City of Plymouth Planning Commission

Regular Meeting Agenda

- a. **SP26-03:** Special land use request for indoor recreation uses at 350 S. Mill. The property is zoned I-2, Heavy Industrial.
- b. **PUD26-01:** Preliminary PUD request for multi-family use at 639 S. Mill and 188 E. Ann Arbor Trail. The properties are zoned Expired PUD.

SUBJECT: SPECIAL LAND USE PERMIT APPLICATION COMMENT RESPONSES

ARCHITECTURAL SITE PLAN

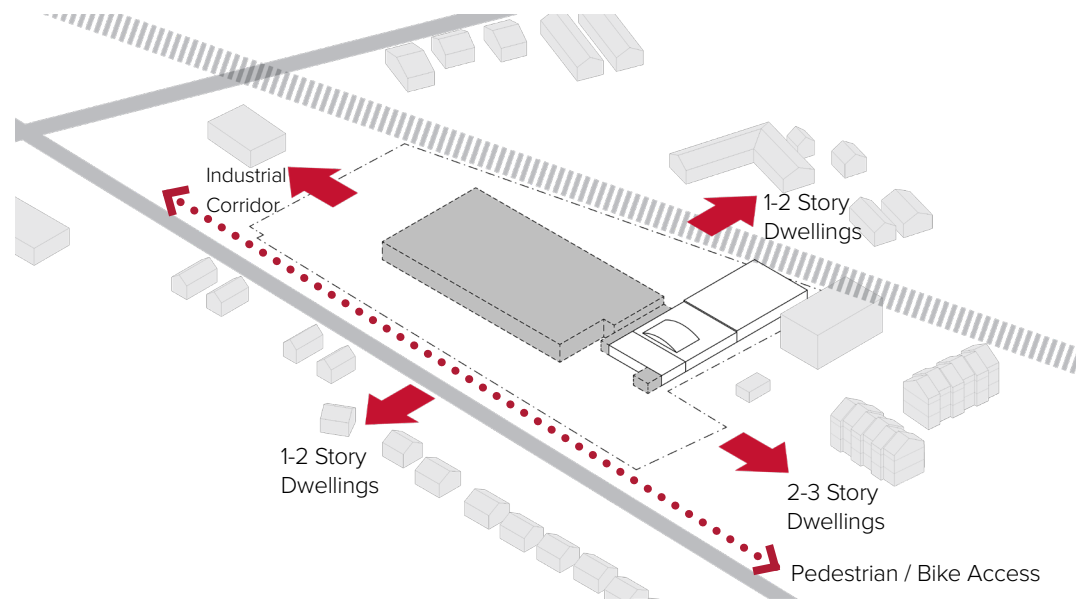
- Show square footage of this area
 - See attached floor plan.
- Provide the number of parking spaces in each bay, dimensions of sidewalks, dimensions of barrier-free parking spaces, dimension of green space between property lines and edge of parking lot on site plane.

Date: 10/14/25
Scale: 1"=40'
Sheet: C-200
Project: 20713.00

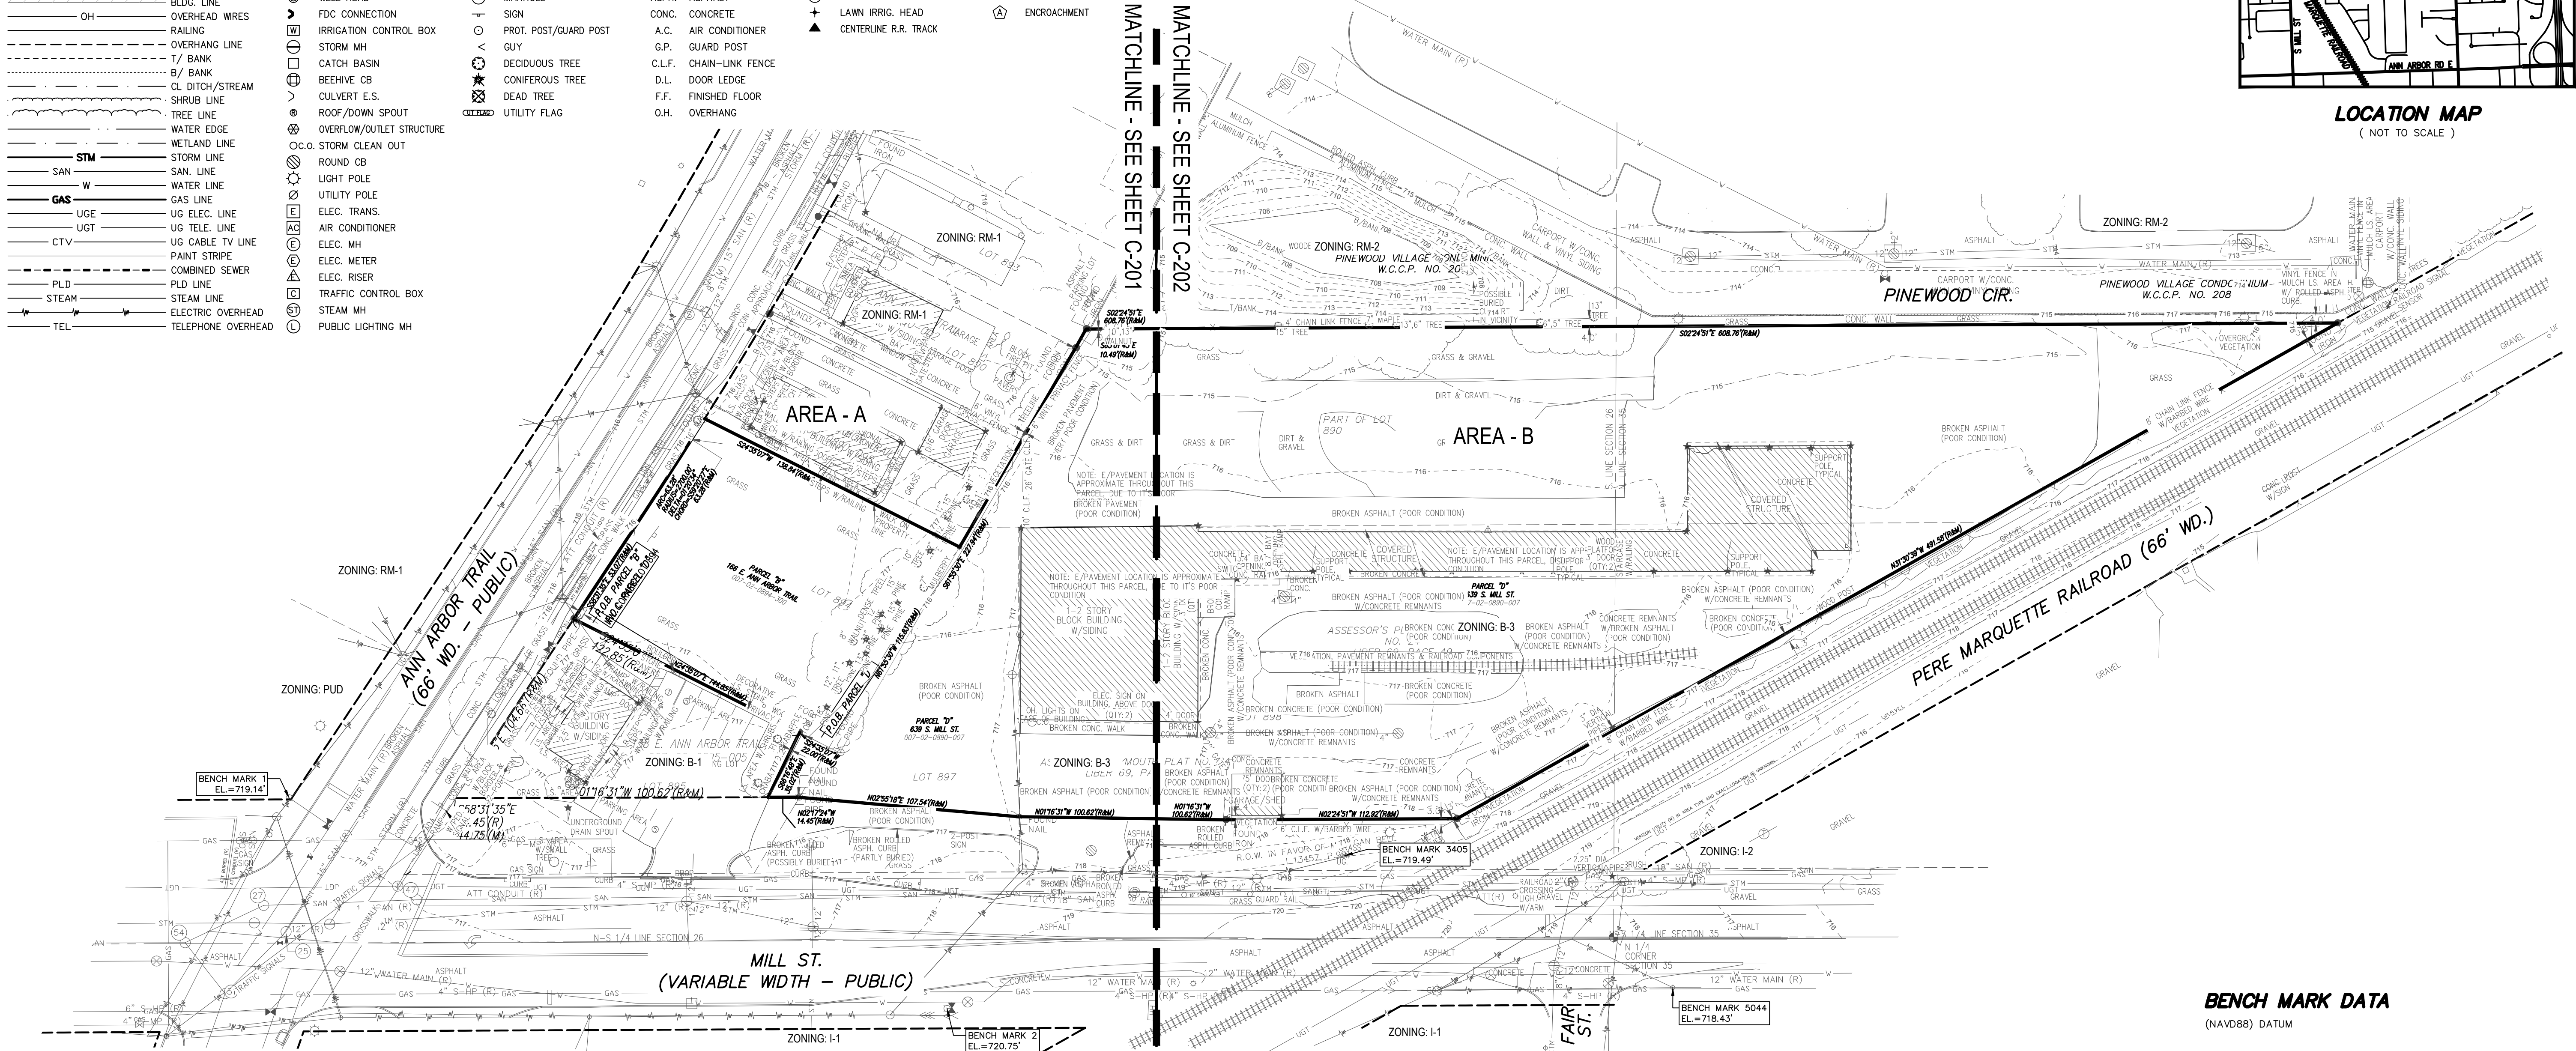
- A. The property does not appear to fall within any regulated flood plain.
- B. The cover sheet indicates that the topographic survey was collected in April 2016. Per the benchmark data shown on the plan sheet C-200 “Existing Conditions Overall”, the North American Vertical Datum (NAVD 88) was utilized. The horizontal datum does not appear to be noted. Four benchmarks are shown on the plans that have been submitted. The benchmarks should be protected during any future construction.

Date: 10/14/25
Scale: 1"=40'
Sheet: C-500
Project: 20713.00

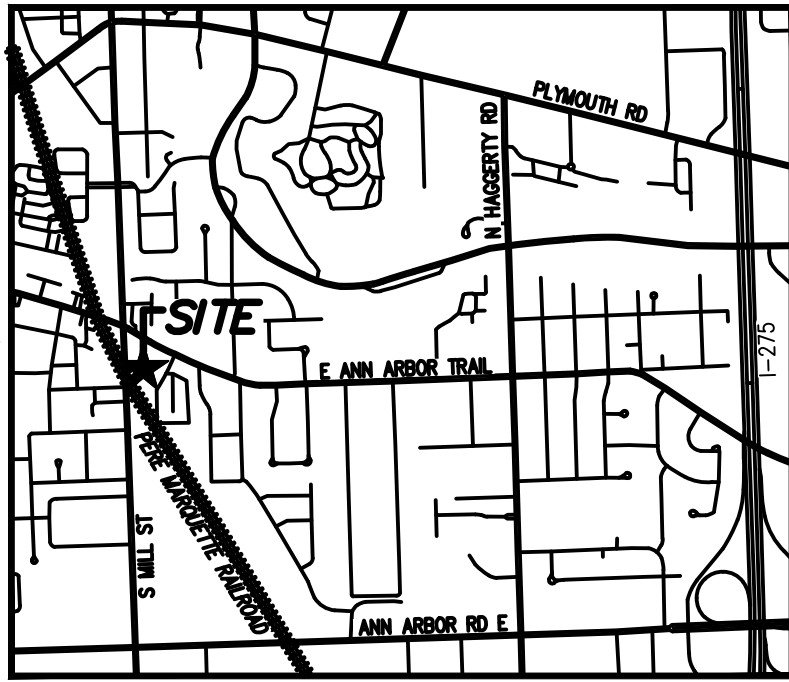
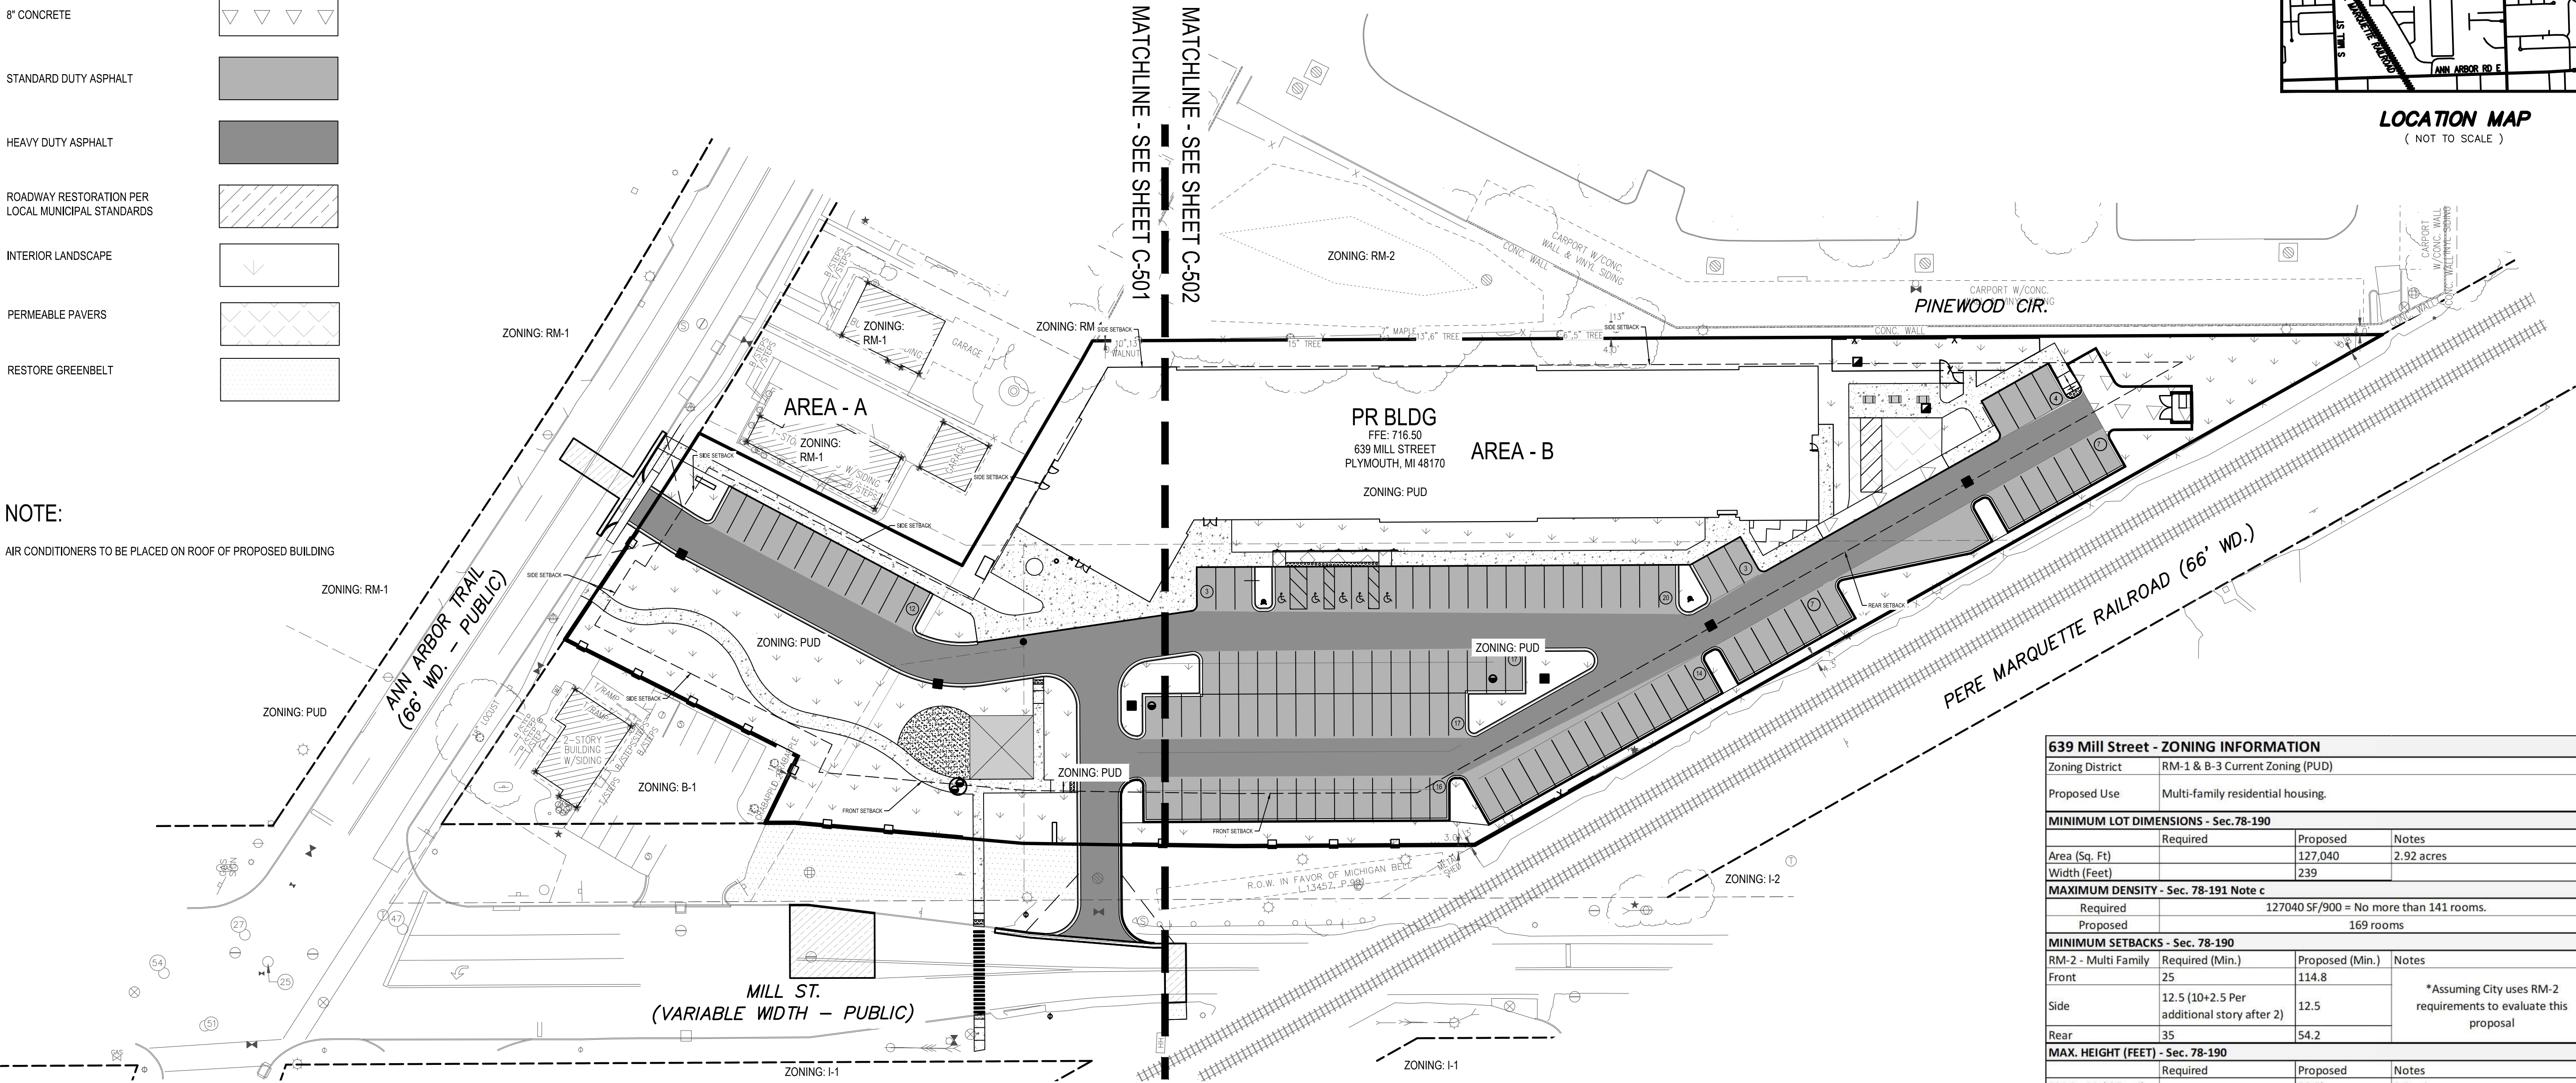
- E. The proposed building appears to be three stories in height. The total square footage is shown on Plan Sheet A.100 as 77,341 square feet with 78 units proposed. Plan sheet C-500 "Geometric and Paving Overall" indicates 169 proposed rooms and shows two parking spaces per 81 units for a total of 162 parking spaces required. The number of units should be consistent across all plan sheets so that the required number of parking spaces can be correctly shown.

- F. The PUD is requesting a 25% reduction in the number of parking spaces (identified as a reduction of 44 spaces on plan sheet C-500).

- A. Plan sheets C-500, C-501, and C-502 provide details regarding the geometric layout for the proposed parking lot. Plan sheet C-500 provides a table with proposed vs. required zoning requirements.
- B. As mentioned above, it appears that 162 parking spaces are required, but only 125 are currently proposed. There is a note on plan sheet C-500 stating that the PUD will request a 25% variance parking reduction. It is unclear if the amount of the reduction should be 37 ($162-125=37$) or 44 as stated on plan sheet C-500.
- C. All proposed parking spaces are shown as 9 feet wide and 20 feet long, consistent with Chapter 78, Article XXII (Parking, Loading Requirements) of the City’s Code of Ordinances.
